RE: Proposed Addition to the Church at
261 Main Street
Maidencreek Township, Berks County, PA
GVC No. 3026-007

MAIDENCREEK CHURCH

ADA ENTRANCE ADDITION

SHEET NO.: CONSTRUCTION A-1.0

OVERALL SITE PLAN

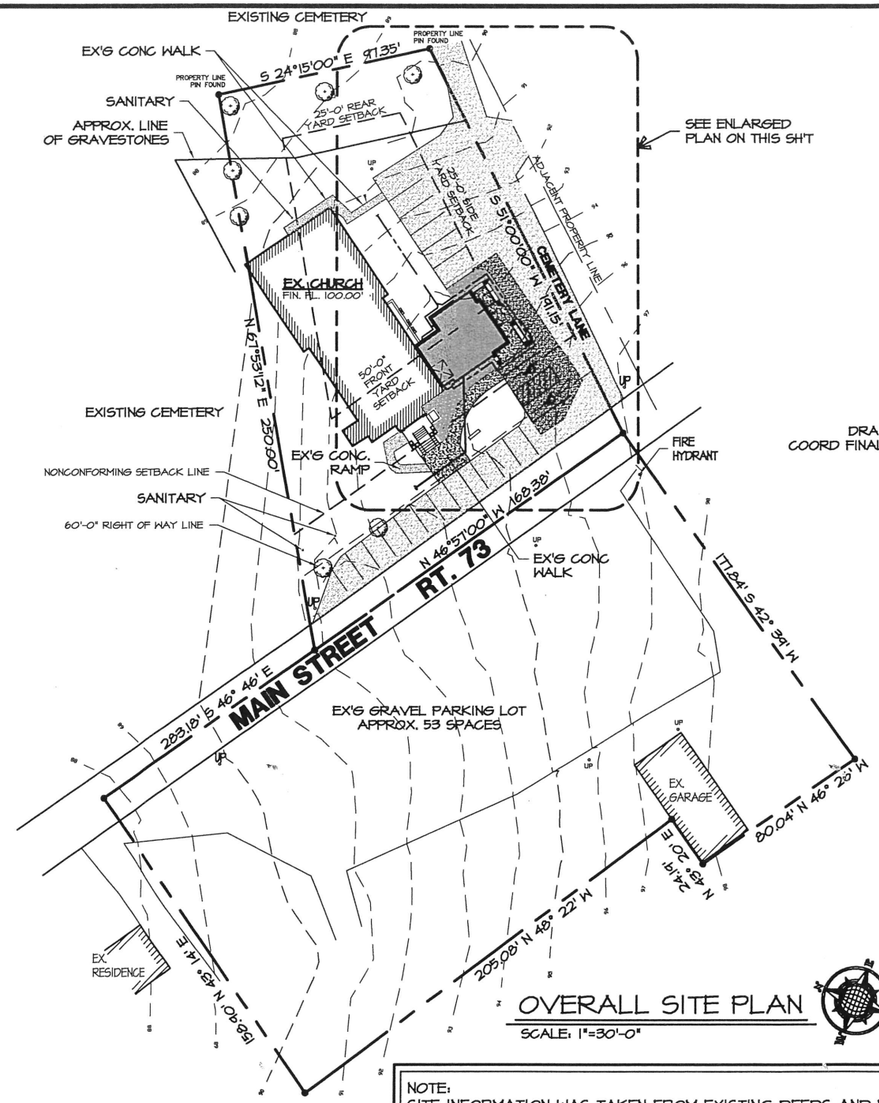
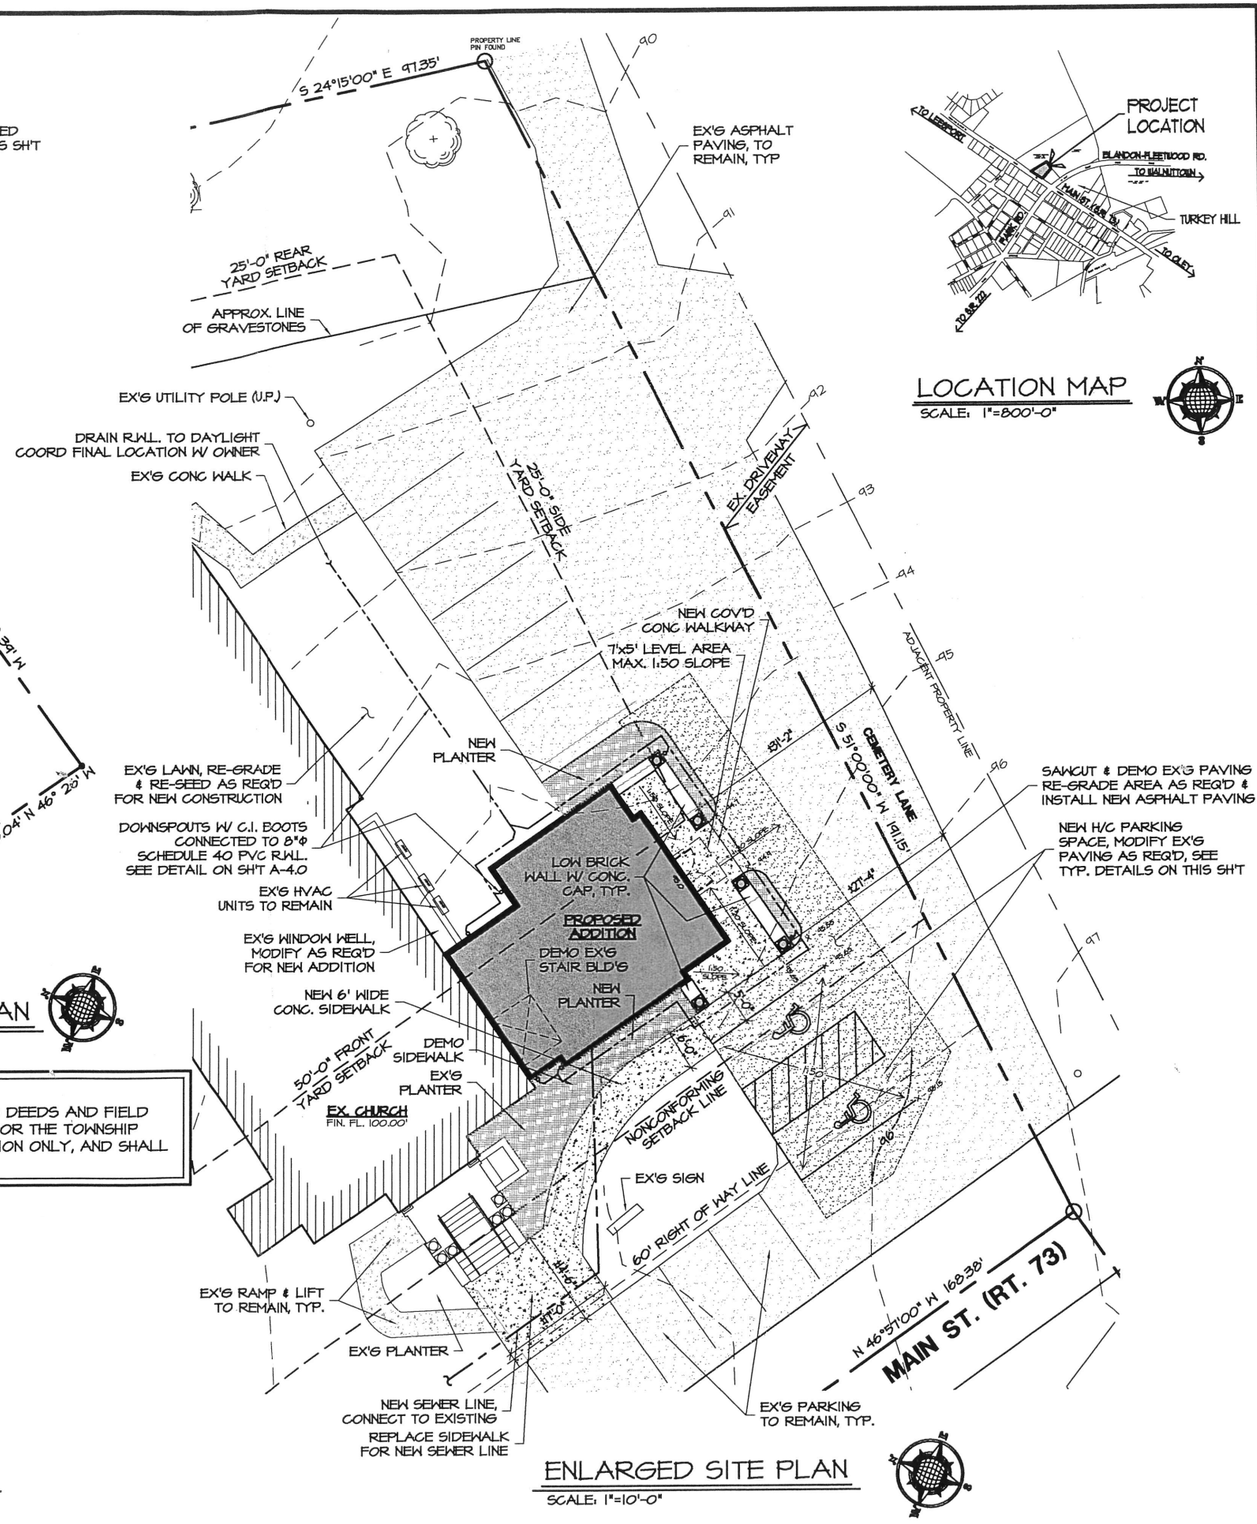
4. Drawing No. A-1.0, dated March 4, 2019 as prepared by Watkins Synergetics Architects of Fleetwood, PA, contains the Overall Site Plan that shows the proposed addition to the Church building. This plan shows that the existing church building encroaches on the fifty (50') foot required front yard setback. Therefore, the existing church building would be considered existing non-conforming with regards to this setback.

5. The proposed addition to the church would be permitted per Section 220-106(a) of the Township's Zoning Ordinance. This section allows an existing non-conforming building to be expanded by up to 25%. The proposed addition is 18.3% of the existing building.

6. The proposed addition would be aligned and match the front face of the existing church. However, the addition would be encroaching on the front yard setback. The proposed addition also encroaches on the side yard setback on the eastern side of the property.

These encroachments would require a variance from Section 220-42(A) of the Township's Zoning Ordinance.
